SUBJECT: Anti-Theft System (DWA) False Alarm caused by Inclination Sensor (NAG)

MODEL: 5 Series (E34, E39), 7 Series (E32, E38), 8 Series (E31)

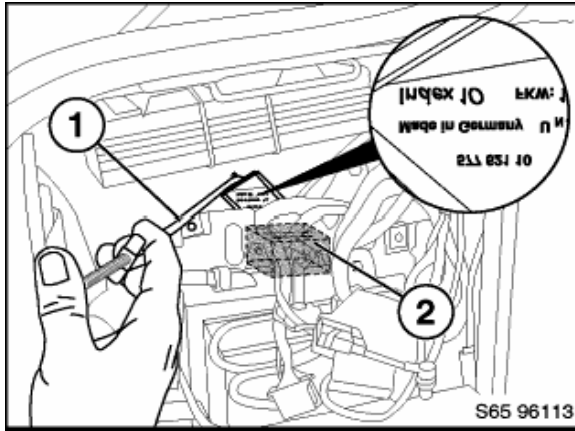
6. If the inclination sensor (NAG) bears an index number of 10 or lower, it must be replaced with an NAG bearing an index number of 11 or higher.

Identify the Index Number by using a mirror (see illustration) before removing the NAG.
